**OFFICIAL COORDINATION REQUEST FOR
NON-ROUTINE OPERATIONS AND MAINTENANCE**

COORDINATION TITLE- 16BON02
COORDINATION DATE- 25 January 2016
PROJECT- Bonneville Dam
RESPONSE DATE- 11 February 2016

Figure 1. Area where the Bradford Island count station modifications will be occurring.

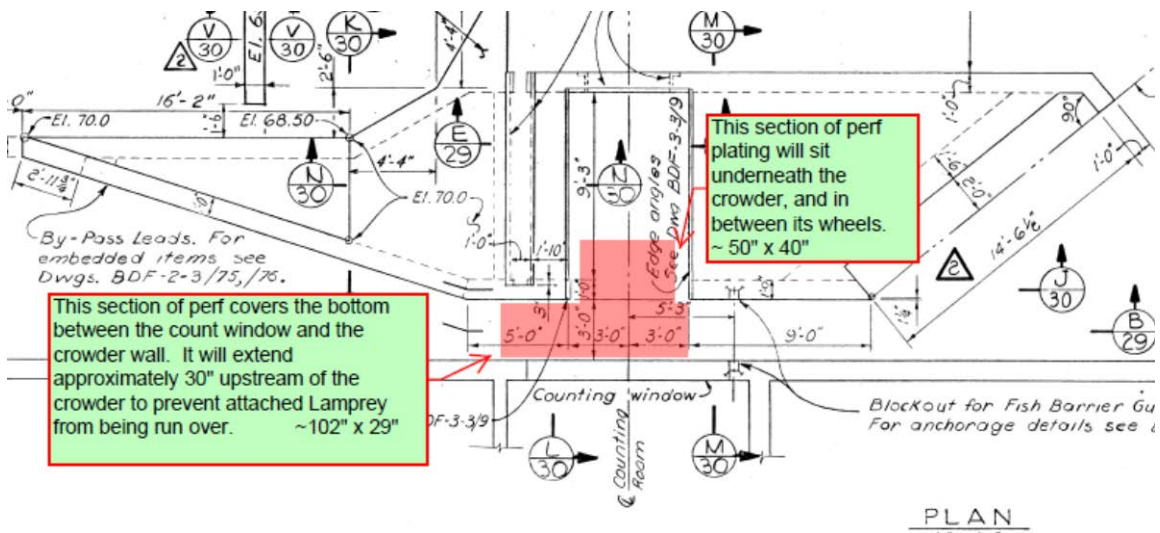
To address these issues, we are in the process of installing perforated aluminum plating to the bottom of the fishway in front of the crowder and a rubber strip to the bottom of the front of the crowder (Figures 1 and 2). The plating (1/8” thick, 1/8” holes staggered at 3/16”) prevents lamprey from being able to suction to the bottom. Thus they will have to swim through the counter window area, ameliorating the counting issue and preventing lamprey from laying in the path of the crowder. The rubber strip will prevent lamprey from getting underneath the crowder. It will be cut from ~1/2” thick heavy duty rubber, will be bolted to the front bottom of the crowder using rounded top bolts (same as those used on the rest of the front of the crowder) to avoid any sharp edges. The ends of the strip will be rounded off, also to avoid sharp edges. It will sit flush on the perf plating. All perf plating edges will be rounded or beveled.

Figure 2: Close-up view of the proposed count station modifications.

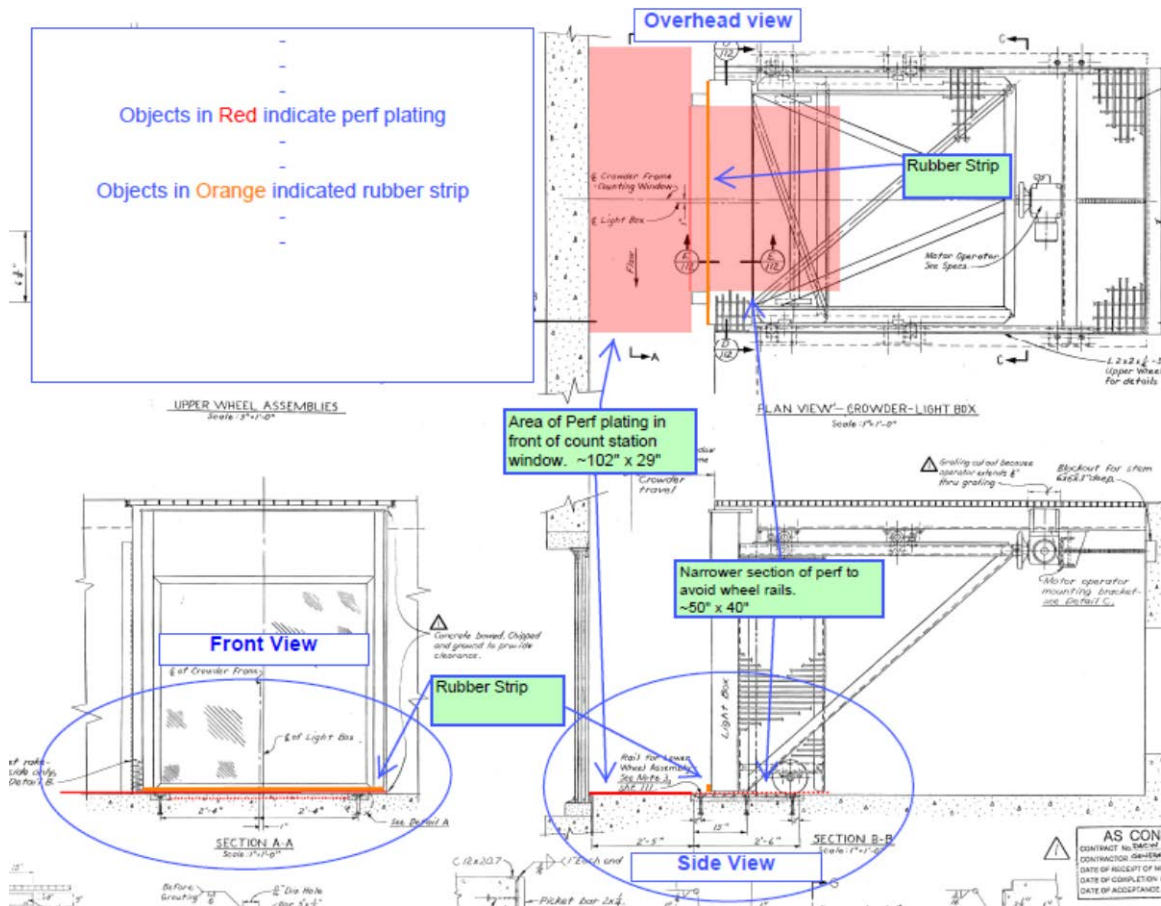
As discussed today, I don't expect these plates to cause hydraulic issues with salmon through the count station.

Recommend small holes with high porosity, and taper the upstream and downstream edges.

Recommend some at least some extension (2'?) past the count window so that the edges are not in the vicinity of the crowder zone.

Final results – Approved at the 2/11/16 FPOM meeting.
